ALERT SERVICE BULLETIN

NO. 430-02-24

MODEL AFFECTED: 430

SUBJECT: ISOLATION OF FADEC-ECU POWER SUPPLIES

No.1 FADEC-ECU Power Supply Wiring Diagram

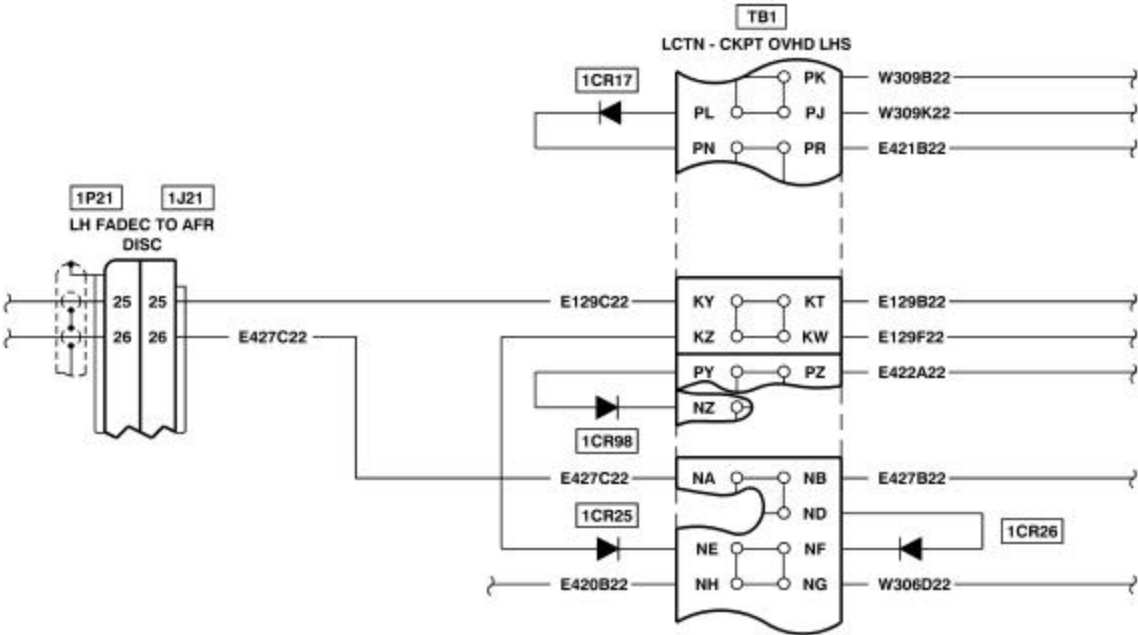
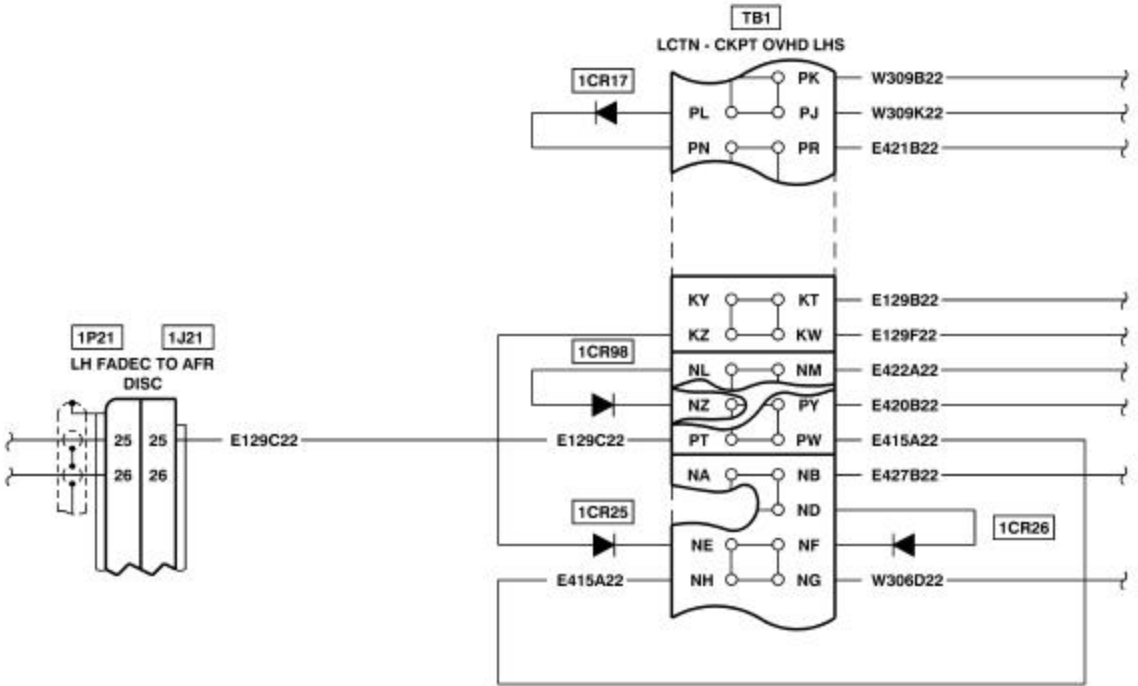
DC power is supplied to each FADEC-ECU from the No.1 DC Emergency Bus and the No.2 DC Emergency Bus. If there is a failure of one of the Emergency Busses there is a possibility that the failed bus may now be supplied with electrical power from the serviceable Emergency Bus via the FADEC-ECU, causing the FADEC-ECU circuit breakers to trip.

This bulletin revises the system wiring to isolate the two DC power inputs to the FADEC-ECU.

5. At Sta 171.67, locate terminal block TB1. Using an extraction tool, P/N M81969/14-01, remove wire, E427C22, from module N, position A. Cut off the contact and cap the wire using end cap, P/N 30-266-1.

6. At terminal block TB1, remove diode, (1CR25), from between module K, position Z and module N, position E, using an extraction tool, P/N M81969/14-01. Discard the diode.

7. Insert the new diode assembly (1CR25), P/N 30-251-1CC, into TB1, between module K, position Z and module N, position E, using an insertion tool, P/N M81969/14-01. (Insert the cathode (grey or silver line) into position NE).

8. At terminal block TB1, remove diode, (1CR26), from between module N, position D and module N, position F, using an extraction tool, P/N M81969/14-01. Discard the diode.

9. Insert the new diode assembly (1CR26), P/N 30-251-1CC, into TB1, between module N, position D and module N, position F, using an insertion tool, P/N M81969/14-01. (Insert the cathode (grey or silver line) into position NF).

10. Using an extraction tool, P/N M81969/14-01, remove diode, 1CR98 from terminal block TB1, module P, position Y, and using an insertion tool, P/N M81969/14-01, insert in terminal block TB1, module N, position L.

11. Using an extraction tool, P/N M81969/14-01, remove wire, E129C22, from terminal block TB1, module K, position Y, and using an insertion tool, P/N M81969/14-01, insert in terminal block TB1, module P, position T.

12. Using an extraction tool, P/N M81969/14-01, remove wire, E420B22, from terminal block TB1, module N, position H, and using an insertion tool, P/N M81969/14-01, insert in terminal block TB1, module P, position Y.

13. Using an extraction tool, P/N M81969/14-01, remove wire, E422A22, from terminal block TB1, module P, position Z, and using an insertion tool, P/N M81969/14-01, insert in terminal block TB1, module N, position M.

14. Using a crimping tool, P/N M22520/7-01, and positioner P/N M22520/7-11, crimp qty 2 new contact, P/N M39029/22-191, on to new wire E415A22.
15. Using an insertion tool, P/N M81969/14-01, insert wire, E415A22, into terminal block TB1, between module N position H and module P position W.

No.2 FADEC-ECU Power Supply Wiring Diagram

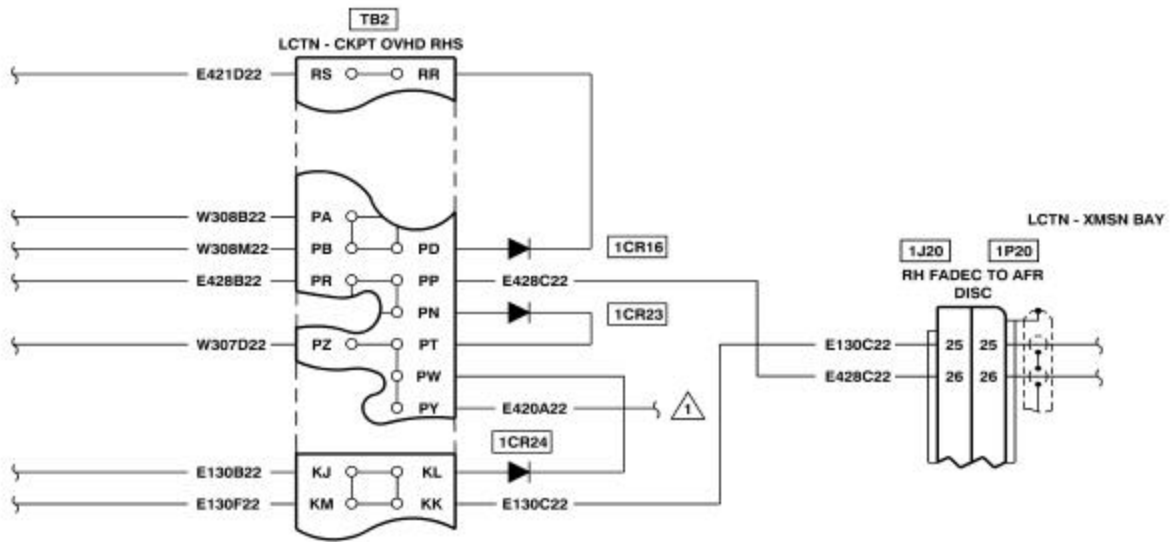
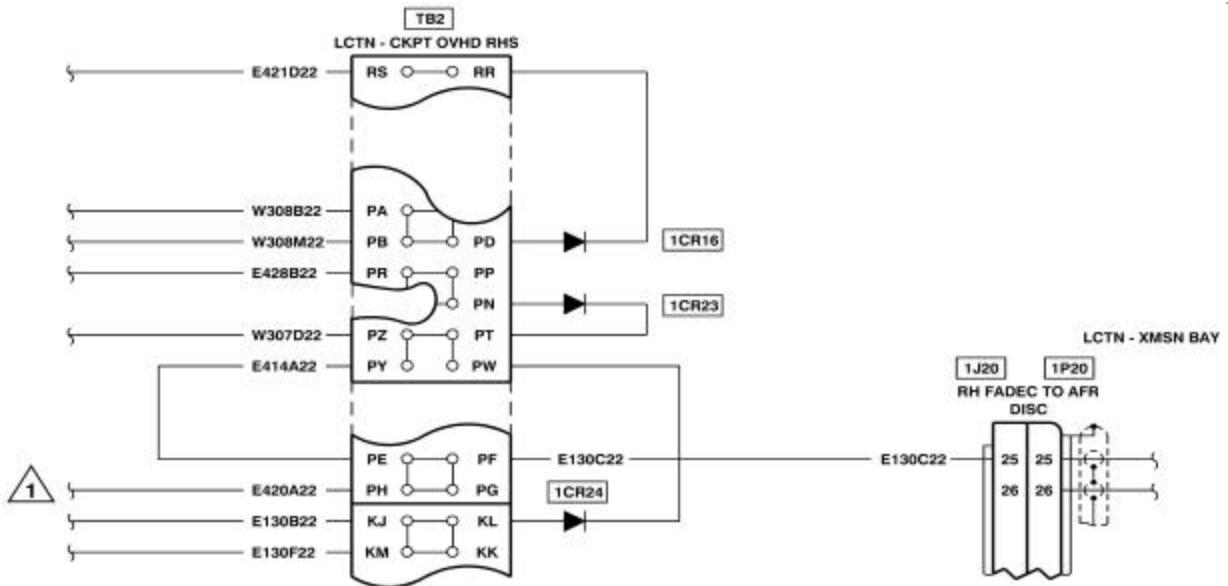
16. At Sta 171.67, locate terminal block TB2. Using an extraction tool, P/N M81969/14-01, remove wire, E428C22, from module P, position P. Cut off the contact and cap the wire using end cap, P/N 30-266-1.

17. At terminal block TB2, remove diode, (1CR23), from between module P, position N and module P, position T, using an extraction tool, P/N M81969/14-01. Discard the diode.

18. Insert the new diode assembly (1CR23), P/N 30-251-1CC, into TB2, between module P, position N and module P, position T, using an insertion tool, P/N M81969/14-01. (Insert the cathode (grey or silver line) into position PT).

19. At terminal block TB2, remove diode, (1CR24), from between module K, position L and module P, position W, using an extraction tool, P/N M81969/14-01. Discard the diode.

20. Insert the new diode assembly (1CR24), P/N 30-251-1CC, into TB2, between module K, position L and module P, position W, using an insertion tool, P/N M81969/14-01. (Insert the cathode (grey or silver line) into position PW).

21. Using an extraction tool, P/N M81969/14-01, remove wire, E130C22, from terminal block TB2, module K, position K, and using an insertion tool, P/N M81969/14-01, insert in terminal block TB2, module P, position F.

22. Using an extraction tool, P/N M81969/14-01, remove wire, E420A22 (S/N 49052 to 49094) or E420C22 (S/N 49001 to 49051), from terminal block TB2, module P, position Y, and using an insertion tool, P/N M81969/14-01, insert in terminal block TB2, module P, position H.

23. Using a crimping tool, P/N M22520/7-01, and positioner P/N M22520/7-11, crimp qty 2 new contact, P/N M39029/22-191, on to new wire E414A22.
24. Using an insertion tool, P/N M81969/14-01, insert wire, E414A22, into terminal block TB2, between module P position E and module P position Y.
